The Waste Isolation Pilot Plant: A Potential Solution for the Disposal of Transuranic Waste

Committee on the Waste Isolation Pilot Plant, National Research Council

The National Research Council (NRC) Committee on the Waste Isolation Pilot Plant was formed in 1978 at the request of DOE to provide scientific and technical evaluations of DOE investigations at WIPP. The committee's statement of task charges it to report on the current state and progress of the scientific and technical issues that form the core of a submission by DOE to EPA for certification of the WIPP facility.

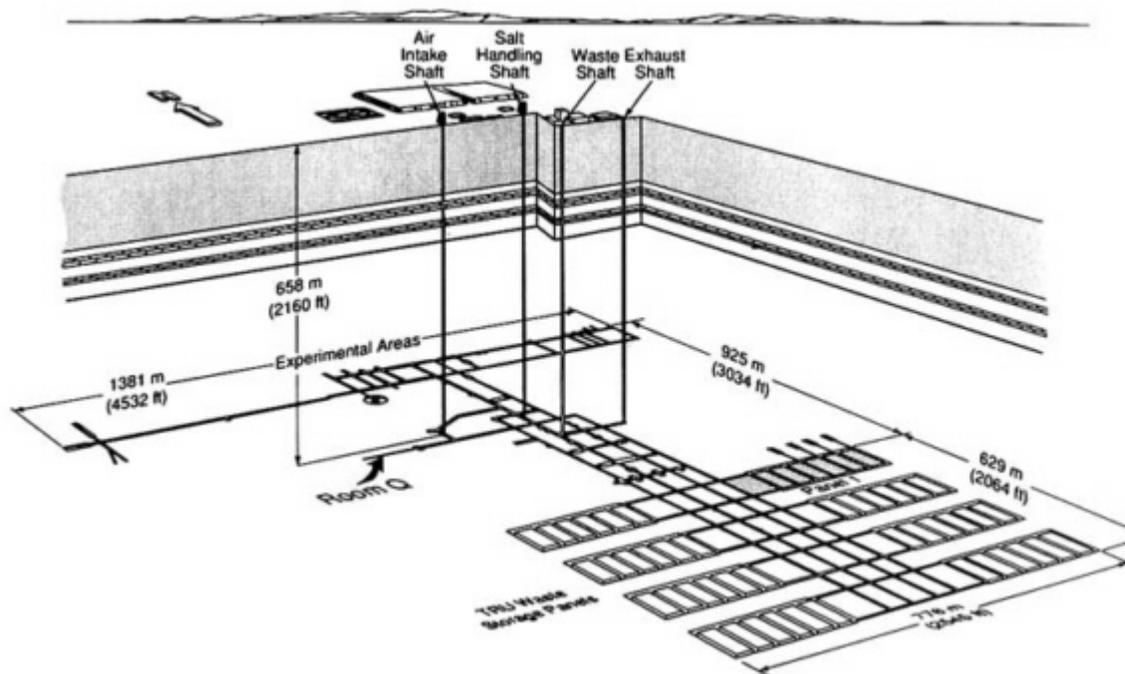
A high degree of compartmentation can be obtained at relatively low cost. The current plan calls for waste panels consisting of seven rooms plus access drifts along each end of the rooms in a "ladder" arrangement ([Figure ES.1](#)). If, after the rooms are filled with waste, the access drifts are backfilled with compacted salt, then a high degree of isolation would be obtained. Changes in the design layout to ensure improved compartmentation seem entirely feasible, especially if, as is currently estimated (DOE, 1995c), the TRU waste inventory stored in WIPP is significantly less than the original design inventory. This issue is discussed in more detail in [Chapter 4](#).

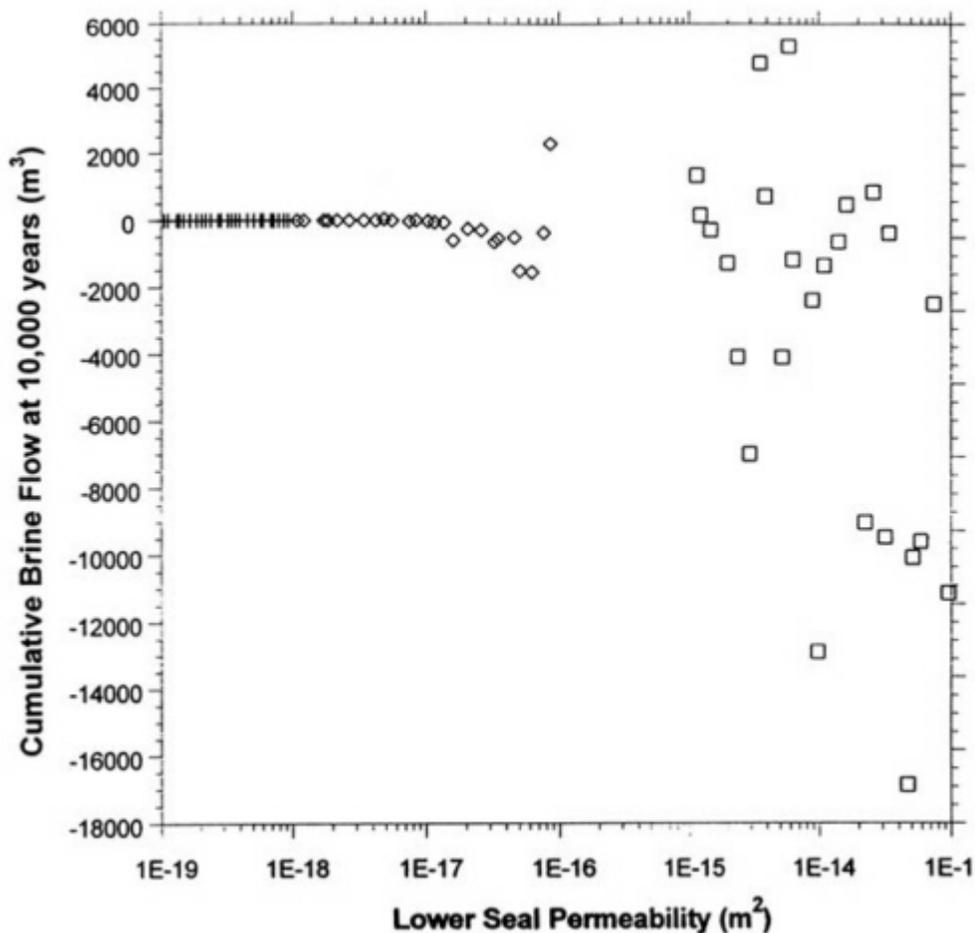
⁴ The seal permeability of 10^{-16}m^2 results in no releases at 10,000 years (see [Figure 4.1](#)). As discussed in [Chapter 4](#), the actual permeability is likely to be even lower than this design value, so that releases beyond 10,000 years are likely to be very small also.

Whether or not drift seals contribute to the overall isolation capability of the repository depends on the credence given to the human intrusion scenarios that must be examined according to 40 CFR 194. For the undisturbed case, PA studies by DOE in which no drift seals are assumed show that the shaft seals alone are sufficient to prevent radionuclide release. Thus, for the undisturbed case, drift seals are not necessary to demonstrate compliance (see discussion of [Figure 4.1](#)).

Figure 4.1 in Chapter 4 of this report shows the results of a number of calculations—each for a randomly chosen combination of repository parameter values (closure rate, brine inflow rate, etc.)—of the cumulative brine flow through the seals over 10,000 years, as a function of seal permeability. It is seen that, especially at the higher permeabilities, flow *into* the repository (i.e., the negative values) tends to be more likely. For a permeability of 10^{-16} m^2 or lower, the net flow is essentially zero.

FIGURE 4.2 Arrangement of the WIPP shaft sealing system. Source: Department of Energy (1995d, Figure 2-1, p. 19).

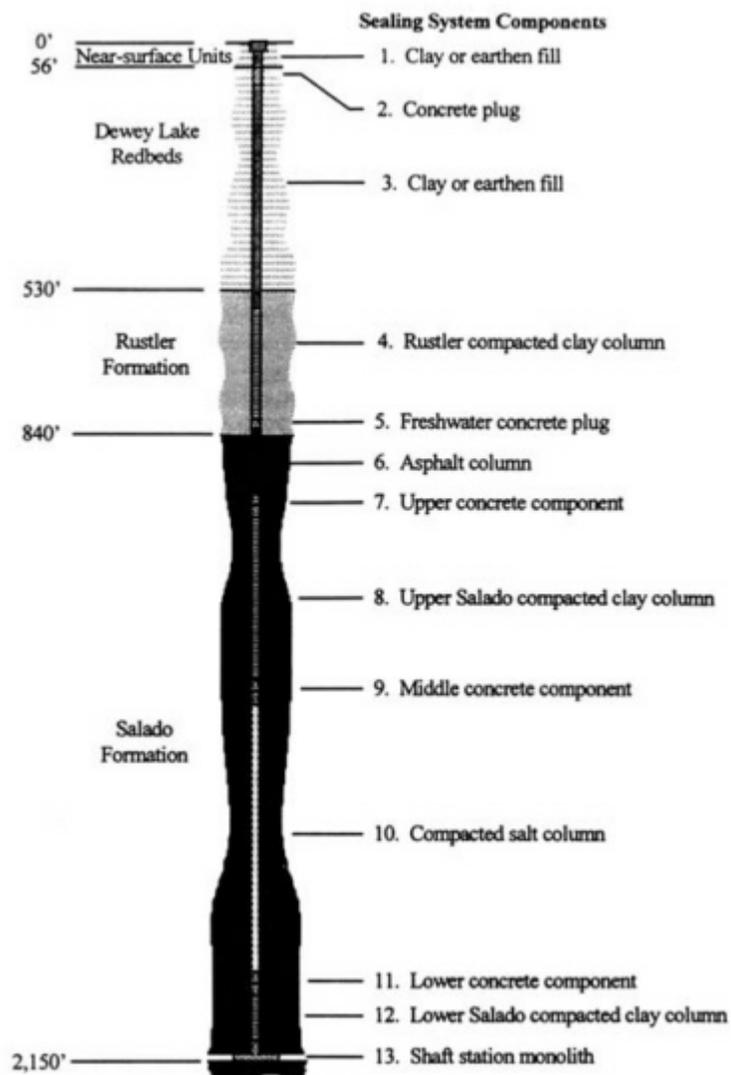
The benefit of retarding release of radionuclides by placing compacted clay columns at various sections in the shaft (Figure 4.2) should be considered fully in the design and PA analysis of the effectiveness of shaft seals. Present PA sensitivity studies model shaft seal permeabilities but not extensive, detailed shaft designs.

In the proposed multicomponent shaft seal system (illustrated in Figure 4.2), reconsolidated salt is expected to constitute the major long-term seal component. Ahrens and Hansen (1995) demonstrated the feasibility of large-scale dynamic compaction of crushed natural salt in a shaft configuration to achieve 90 percent of its intact density, providing greater confidence in the efficiency of its reconsolidation to produce an effective long-term seal.
